# 1993 Corvette: Service Bulletin: Hood Will Not Open - Cable Disconnection

**Subject:** HOOD WILL NOT OPEN, CABLE DISCONNECTED

**Bulletin Number:** 93-151-10

TOOL

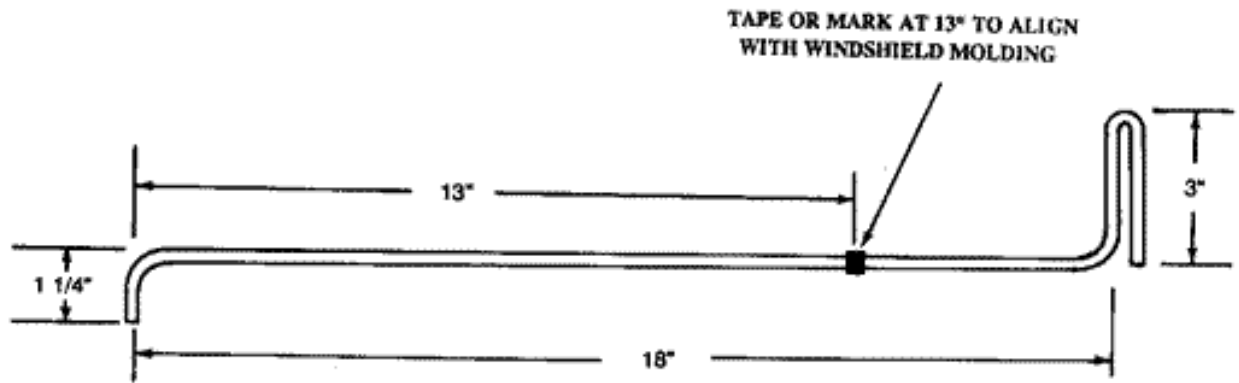
The hood release cable may become disengaged from the hood latch lever.

Replace the hood latches with service P/N's 10210747 (Left) and 10210748 (Right)

- Obtain material locally and fabricate the tool shown on the illustration from 3/16" or 1/4" steel rod.
- With the door open, locate the short bent end of the tool inboard of the vertical flange of the hood latch support.
- insert the tool forward until the tape is aligned with the lower end of the windshield pillar molding.
- Twist the tool to contact and move the latch lever until the latch disengages. A slight downward pressure on the hood in the latch area may be helpful to disengage the latch lever.

TOOL IN POSITION  
(DOOR REMOVED FOR ILLUSTRATIVE PURPOSES)

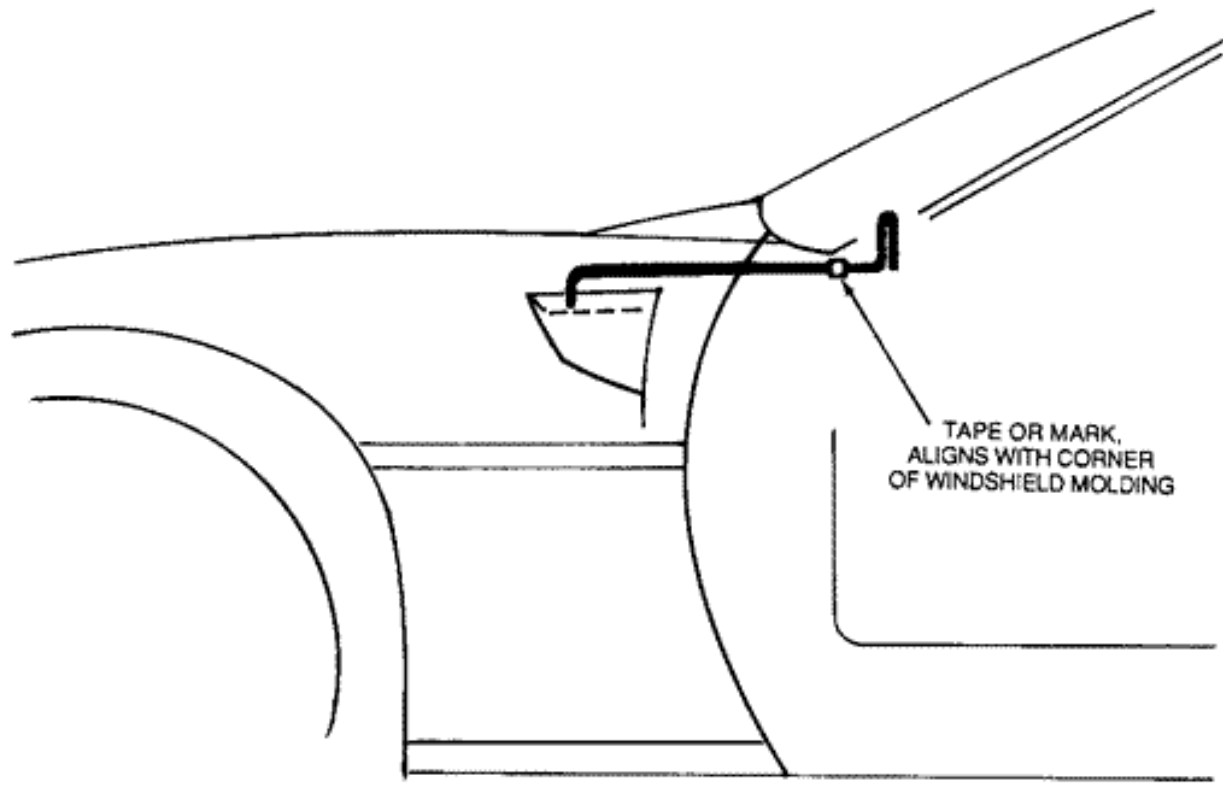
**NOTE: Opening the hood will require the following:**
